JAR VLR NPA 1

Comment Response Document

13. VLR.303

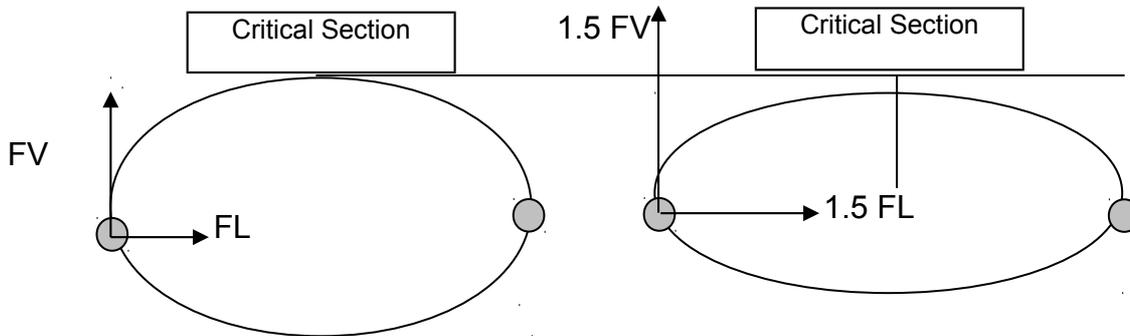
Although present in both existing rotorcraft codes, this sentence does not appear in the fixed wing codes. It is possible that this requirement is intended to address a case where internal load is not proportional to an applied external load such as a pre-loaded joint or assembly. However, the circumstances where this is appropriate, practical or beneficial are not clear.

The sentence has already caused confusion on several projects and should either be amended and/or supported by interpretative material with clear examples. It is understood that this comment applies to part 27/29 as much as VLR and action must be taken to effect a change to all three codes as necessary.

Not accepted. Comment understood, however once again we should not forget that we are dealing with helicopters structural components that in some cases may be quite different from those installed on a fixed wing aircraft. (eg. main rotor blades).
